Information BULLETIN

Issue No: MG016B Date: 18th February 2017

- i McMurdo SmartFind EPIRB – All Versions
- i Kannad Marine EPIRB, Sport/Sport Pro/Sport Pro +

Top dome replacement

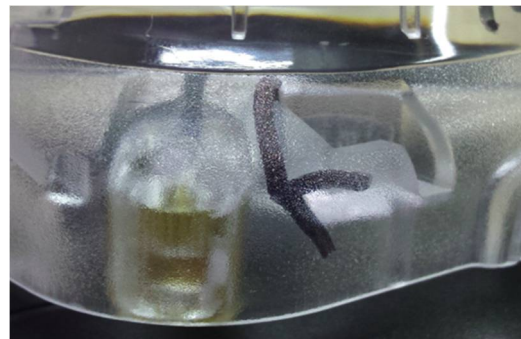
It has come to our attention that the top dome under certain circumstances may begin to show signs of localised craze cracking. Small cracks may appear to be radiating out from the three over moulded screw inserts.

The cracking area is outside of the waterproof seal (main O ring seal) in a wet zone which is a self-draining cavity. As such, any cracking in this area will not compromise the waterproof body seal in anyway, or significantly weaken the overall integrity of the EPIRB.

1. Clearly, any cracking is undesirable and unsightly and our recommendation is that the EPIRB should be subject to rectification work at earliest opportunity.
2. Should you have any concern with regarding the condition of your EPIRB you are invited in the first instance to contact the McMurdo customer support team for advice.
3. If the EPIRB is in warranty period, complete an RMA application using the online form:-
